TANDBERG TAPE RECORDER INFORMATION

No. 104
Oslo, 2nd December 1970

Series 3000X/6000X

Modified take-up clutch

Bottom view of take-up turntable and friction disc.

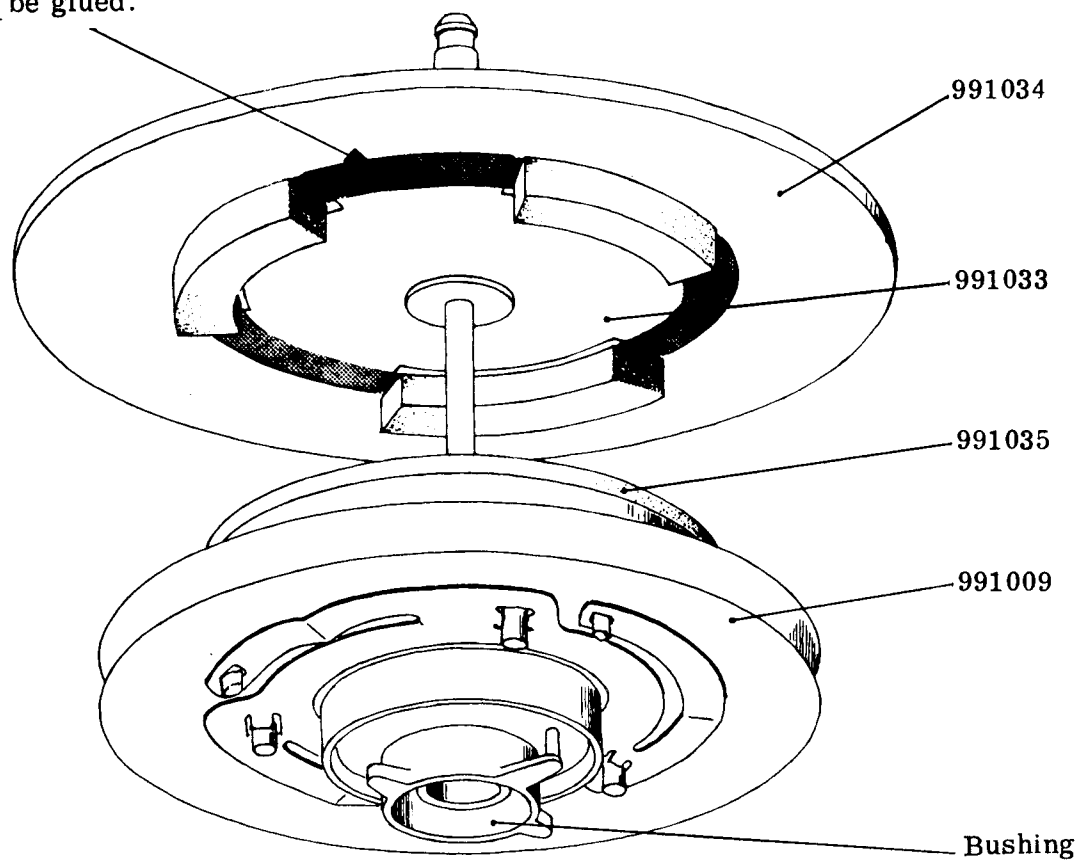
The materials originally used in the take-up clutch have after prolonged operation in hot environments in some cases shown a tendency of excessive wear.

Clutch components in a better material were introduced in production from the following serial numbers:

In some units, the bushing in the friction disc has a wide flap instead of a small stud to prevent rotation. The bushing with the flap can be snapped out of the bearing by means of a screwdriver and must be installed in the new friction disc to facilitate the rest of the assembly

The hatched areas indicate the adhesive coating holding the friction pads. The mylar sheet must not be glued.

1 ea take-up turntable with friction
pads, and mylar sheet with felt part No. 991034

1 ea take-up friction disc with
coupling disc, spring, ball bearing
and bushing part No. 991009
